TOWN OF UNDERHILL

Development Review Board

MARTY BASLOW
SKETCH PLAN REVIEW
Docket #: DRB-19-10

Project Proposal: Sketch Plan Review of Marty Baslow for a proposed 2-Lot Subdivision of property located at the aforementioned address.

SECTION 3.18 – STEEP SLOPES

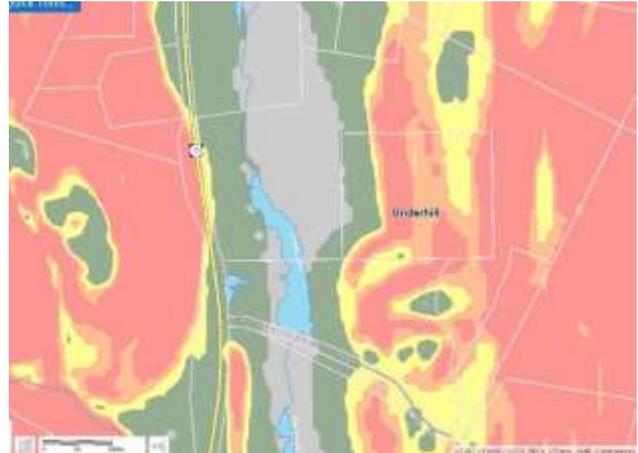
- Areas of steep slopes (15-25%) are present on the existing lot (see directly to the right).
 - Based on the subdivision’s configuration, Parcel A seemingly has no area where development is feasible due to steep and very steep slopes.
 - The one area that is under 15% slope is close to the property’s boundary and would likely require a dimensional waiver or variance.
